Access Compliance Report

Public Rights-of-Way

(Curb Ramps)

Intersection ID: 48582	Main Street: WATERLILY_LN	Cross Street: SWEET_FLAG_CT	Location: NE
ADA ID: F3F5C272EDAB	Ramp Type: PerpDiag	Initial Pass/Fail: Fail	Overall Compliance: No
Severity Score: 22.5			
Codes/Mitigation Info/Possible Solution		Field Measurements/Component Compliance

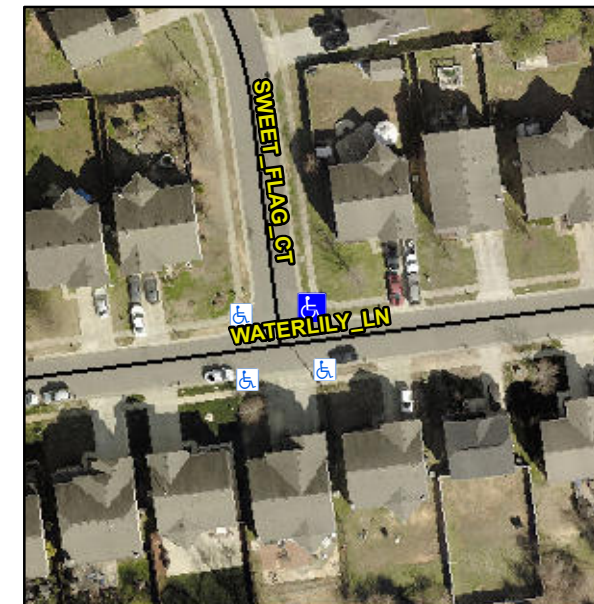
Not Found, R304.5.1, R304.2.2, R304.5.3

Compliance	Description	Data	Compliance	Description	Data
N/A	Ramp Length (in)	48.0	No	Ramp Slope (%)	10.5
No	Ramp Width (in)	47.0	No	Ramp XSlope (%)	3.5
N/A	Flare Type LT	N/A	N/A	Flare Type RT	N/A
N/A	Flare Slope LT (%)	N/A	N/A	Flare Slope RT (%)	N/A
N/A	Flare Traversable LT?	N/A	N/A	Flare Traversable RT?	N/A
N/A	Landing Length (in)	N/A	N/A	DWS Provided?	N/A
N/A	Landing Width (in)	N/A	N/A	DWS Contrast?	N/A
N/A	Landing Slope (%)	N/A	N/A	DWS Length (in)	N/A
N/A	Landing X Slope (%)	N/A	N/A	DWS Full Width?	N/A
N/A	Landing Curb? (Y/N)	N/A	N/A	DWS Offset (in)	N/A
N/A	Shared Landing?	N/A			
N/A	Gutter Ponding?	N/A	N/A	Gutter Slope (%)	N/A
N/A	Gutter Lip Ht (in)	0.5	N/A	Gutter X Slope (%)	N/A
N/A	Painted X Walk1?	No	N/A	Painted X Walk2?	No
	X Walk 1 Direction	To W		X Walk 2 Direction	To S
N/A	X Walk 1 Width (in)	N/A	N/A	X Walk 2 Width (in)	N/A
	X Walk 1 Slope (%)	0.3		X Walk 2 Slope (%)	3.4
	X Walk 1 X Slope (%)	2.3		X Walk 2 X Slope (%)	2.2

Remove & Replace Curb Ramp With Two New Directional Ramps or Equivalent.
